Addendum for Bid
Riverside Park Renovations, Phase I
14-894

Date: February 28, 2014
From: Stephanie Suter, CPPO, CPPB
RE: Addendum No. 1

RIVERSIDE PARK RENOVATION
PHASE 1
City of Lynchburg, VA
EN06-118-108, P101, C501

A NATURAL RESIN EMULSION O.R.A.R.

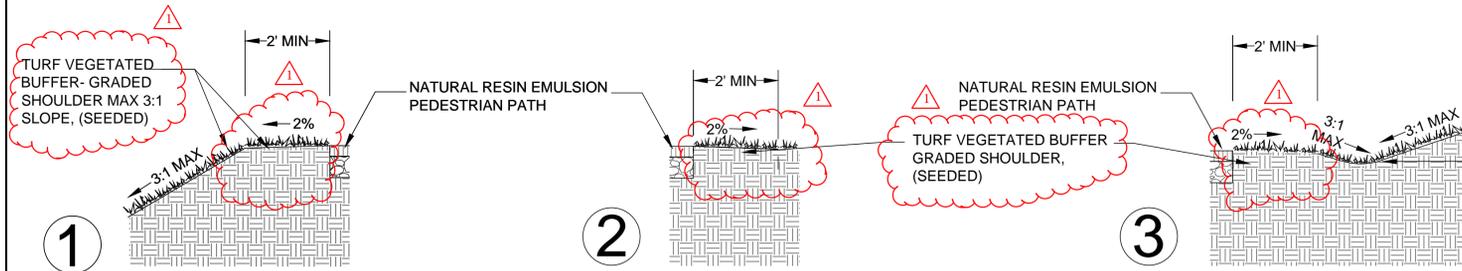
7. If the details on L-107/16 relate to alternate 4, what details show the base bid pedestrian path configuration?

11. What does the abbreviation O.R.A.R. on detail A on L-107/16 stand for?

Details show reinforced shoulder to be included in Base Bid Alternate 4. See revised details A and B on sheet L-107, Sheet number 16 (attached) for revised base bid pedestrian path configuration.

Outdoor Recreation Access Route (ORAR). See Sheet G-001/Sheet 1 General Project Description for definition.

D CONCRETE PAVER PATTERN + PLAN FOR BENCHES IN PAVER AREAS

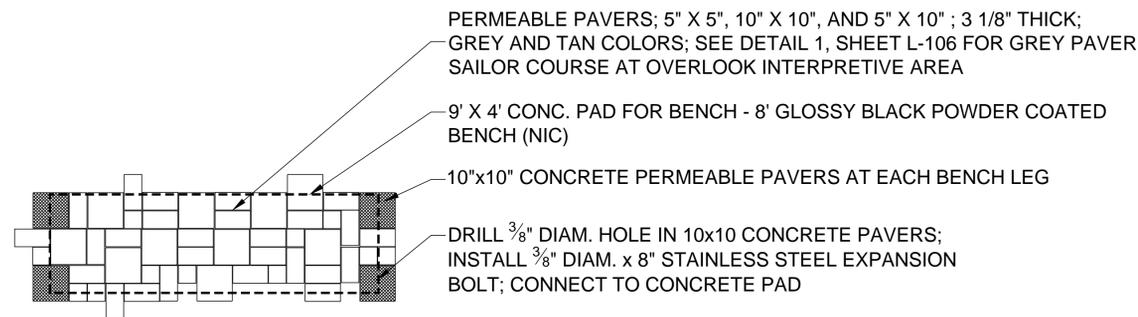
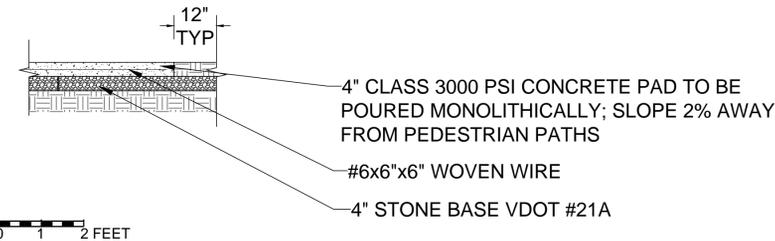
2. The specs call for a matching 3/8" paver on top of the concrete slabs to attach the benches, this doesn't exist. This should use the same paver and should stub up from the slab through the full size paver and tighten down the bench.

Correction to detail D Permeable Pavers – dimension for all paver thickness should read 3 1/8 inch.
